COUNCIL ASSESSMENT REPORT

Panel Reference	PPSSNH-81
DA Number	47/20
LGA	North Sydney
Proposed Development	Demolition of five (5) residential flat buildings, bulk excavation, tree removal and the construction of a 10 storey commercial building with basement parking
Street Address	2 – 4 Blue Street and 1 – 5 William Street, North Sydney
Applicant	Union Street Developer Pty Ltd
Owner	Conway Home Units Pty Ltd (2 – 4 Blue Street and 1 William Street), SP 12338 (3 William Street), SP 16506 (5 William Street)
Date of DA lodgement	11 March 2020
Number of Submissions	<u>Original proposal</u> Forty-five (45) submissions (twenty (20) in support, twenty-five (25) in objection) <u>Amended proposal</u> Fifty-eight (58) submissions (forty five (45) in support, ten (10) in objection, three (3) neutral)
Recommendation	Approval
Regional Development Criteria (Schedule 4A of the EP&A Act)	Capital Investment Value (CIV) of greater than \$30 million

Report prepared by	Luke Donovan, Senior Assessment Officer, North Sydney Council
Report date	7 July 2020

Figure – Amendments to the articulation and treatment of western façade fronting William Street

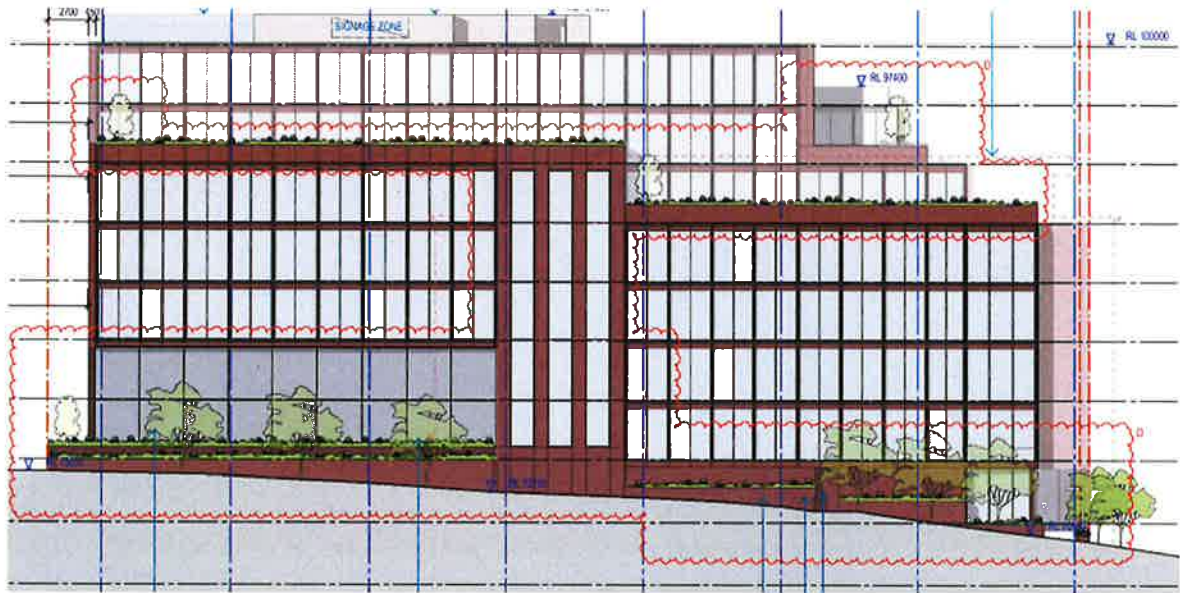
At the William Street ground plane there is limited activation along the street edge. The difficulties presented by level changes across the site are acknowledged, however the provision of a more active street edge should be explored. A setback to the on-grade floor could be considered to provide a more generous public domain. Additionally, it is unlikely that the substantial street trees shown on the landscaping plan will grow in William Street with the nil setback proposed. The provision of two or three building recesses to accommodate the canopies of substantial street trees would also provide the very desirable break in the long western façade. The panel strongly supports street trees on William Street.

The amendments to the façade treatment to William Street are supported. The modified design provides appropriate articulation to assist in breaking up the visual massing.

Further consideration of the William Street ground plane is required. The height of the stepped planters should be removed to allow for a widening of the pavement allowing for an increased soil zone for street trees as well as the incorporation of seating.

- *Additional facade articulation has been introduced to break the length of the western facade. Brick materiality is extended vertically to an upper level spill planter breaking the massing.*

1. Street trees located with additional setback
2. Increased articulation to western facade
3. Street level spill planting and recessed brick facade
4. Additional planting wraps south western corner and connects into the landscaped public stair and street frontage
5. Additional glazing wraps south western corner
6. Level 6 has been set back at its southern half to further articulate a stepping towards Blue Street. Previously this setback happened on the floor above
7. Pedestrian Awning

Figure – Extract from roof plan, area in red outline is representative of the area of plant that is located to maximum RL101.80

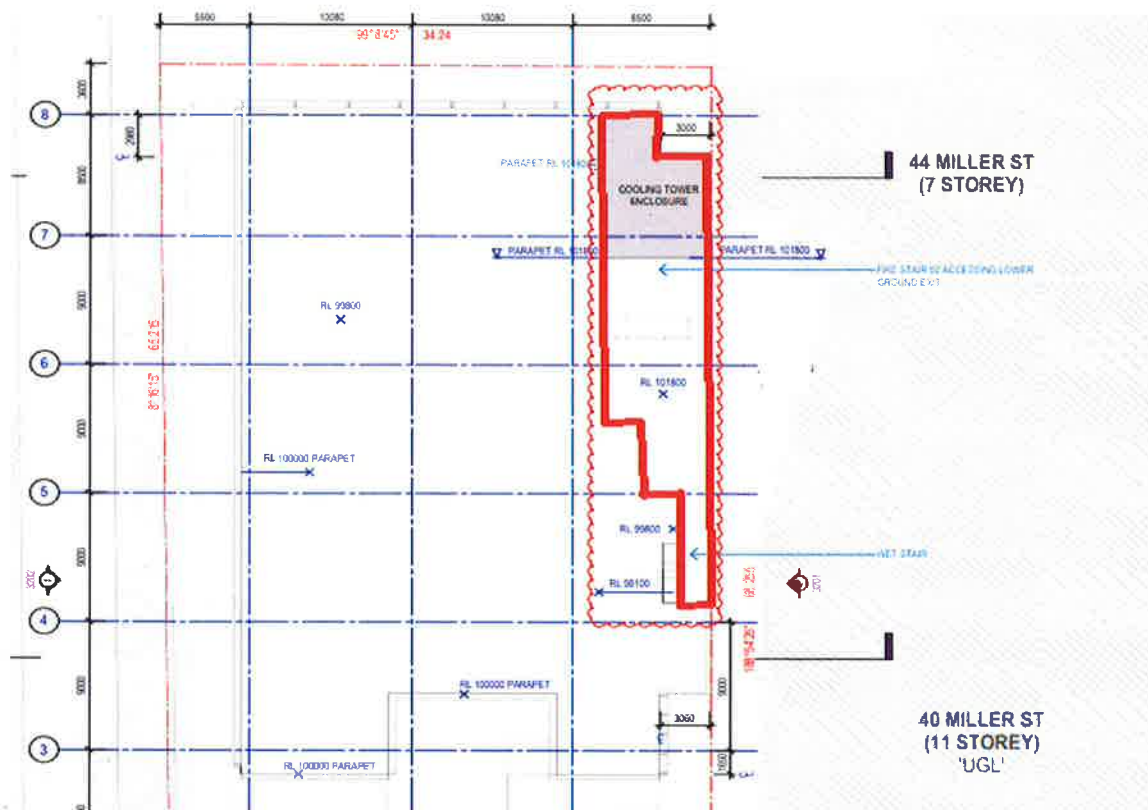
The height of the proposed building to the top of the plant and lift overrun is RL 101.8, which equates to variation of 1.8m (a variation of 1.8%). The proportion of the building envelope above a height of RL100 is shown and red outline in the Figures below. This portion of the building comprises plant and lift overruns. It does not contain any gross floor area.

The VSA indicates that the roof top plant to RL101.8 will not impact significant views from Units 904 or 905 (level 9) given that the plant is located adjacent to the eastern boundary. Furthermore, the top of the roof top plant at RL 101.8 is below the parapet of the building on the adjoining property at 40 Miller Street. The re-design and reduction in the area of the roof top plant under the amended proposal minimizes the extent of view impact. A condition of consent is recommended that the top of any exhaust vents located within the level 08 cooling tower enclosure do not extend above RL100.
